STAR ONLINE PUBLICATION

Case Number: S2114000003

Symptom/Vehicle Issue: Start/Stall And Malfunction Indicator Lamp (MIL) Illumination After Replacement Fuel Line Chassis Bundle Installation.

Figure 1

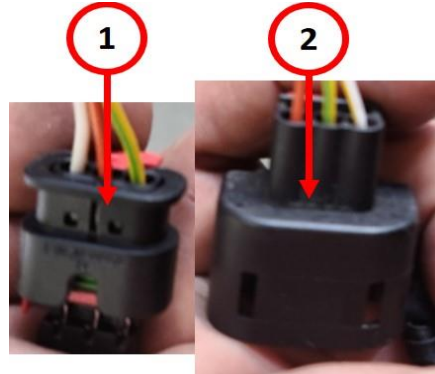
The electrical connector for the newer design fuel pressure sensors are different from the older design. See ([Figure 1](#)). This will require a new electrical connector to be installed (pn# 68137864AA) in order to utilize the new fuel line bundle.

NOTE: The circuit pin locations have also moved to different locations on the new design sensor.

NOTE: Replacement engine harnesses, including the harnesses on replacement complete engine assemblies are also equipped with the new design sensor electrical connector. When replacing these components, please also replace the fuel line bundle. Do not swap the electrical connectors.

Figure 2

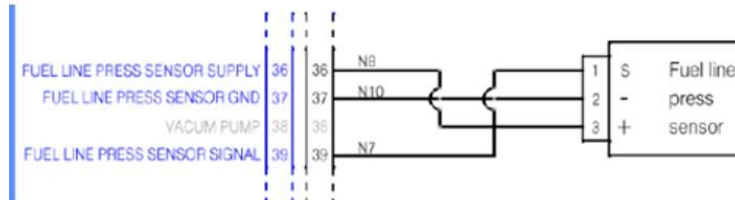
When installing the new connector, it is important to place the circuits in the correct pin location for the new design sensor. Looking at the back of the connector (wire insertion side) with the locking tab up, and starting from the left. Circuit N7 (OG) has moved from pin 1 to pin 2. Circuit N10 (YE/GN) has moved from pin 2 to pin 3. Circuit N8 (WH/YL) has moved from pin 3 to pin 1. See (Figure 2).
